Würth Elektronik eiSos GmbH & Co. KG

Product / Process Change Notification (PCN)

PCN #: PCN_FeSTAR-TEC_20201030

Affected Series: WE-STAR-TEC Series
 7427111x(S); 7427113x(S); 74271142(S);
 7427122x(S); 74271151(S); 74271211(S);
 74271251(S); 742711319; 742712229

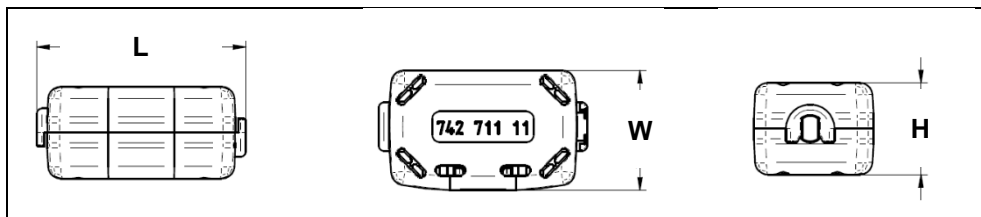
As a datasheet information amendment and correction, Würth Elektronik will change the tolerance type from "typ." to "±" tolerances and the General Tolerances Standard for not specified Dimensions.

Additional the representation of the drawings will be updated and dimensions in the datasheet will be corrected.

- 1. Change:** Tolerance type from "typ." to "±"
- Validity:** STAR-TEC Series
